TRO10032 LOWER THAMES CROSSING

**SUBMISSION AFTER HEARINGS: ISH3, ISH4, ISH5, ISH6, ISH7, and OFH4
held between 5th and 11th September 2023**

SHORNE PARISH COUNCIL (IP ref 20035603)

Design of Structures:

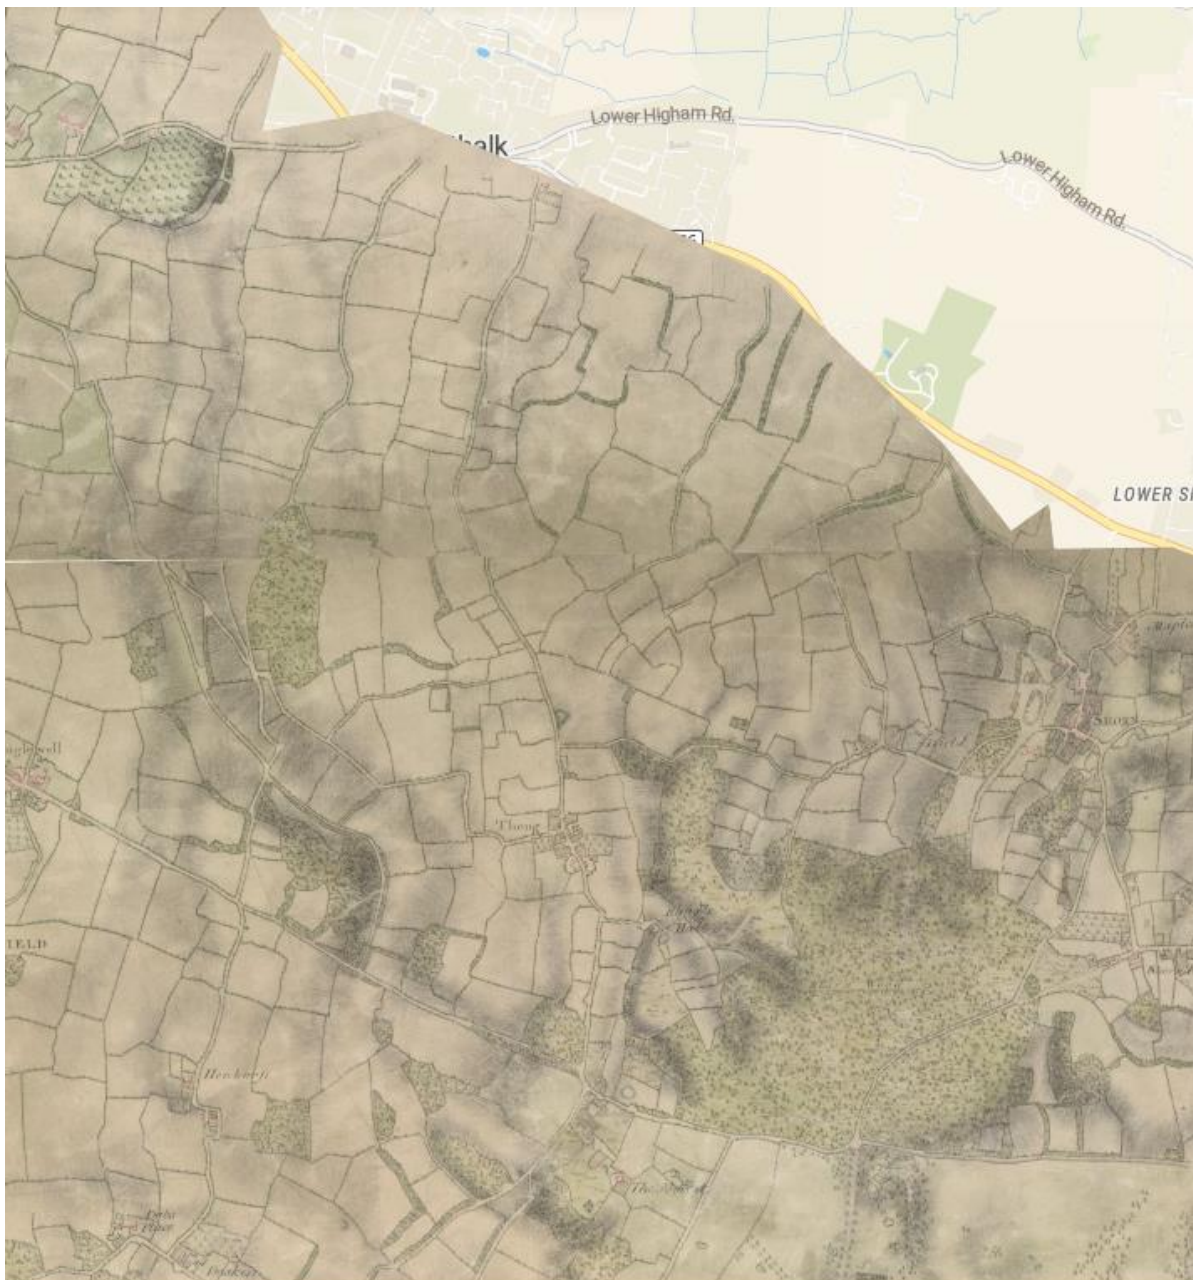
- Regarding the tunnel control building that was mentioned, we were told previously that this would be fully underground but APP-513 Pages 25 and 26 shows this not to have been true. The design should be reconsidered to make it less visually obtrusive and more hidden from view, given the Green Belt location and additional impact on openness. The structure will be very conspicuous in the landscape.
- Ask: We would be grateful for an explanation as to why we cannot have one or more WCH bridges provided south of the Thames such as those proposed for Thames Chase (which we note also crosses a considerable number, maybe 12, lanes of traffic), for example located as far south

as possible across the LTC line to prevent the severance issues and restore connectivity, and also between Shorne Woods Country Park and the south side of the southern two-way connector road.
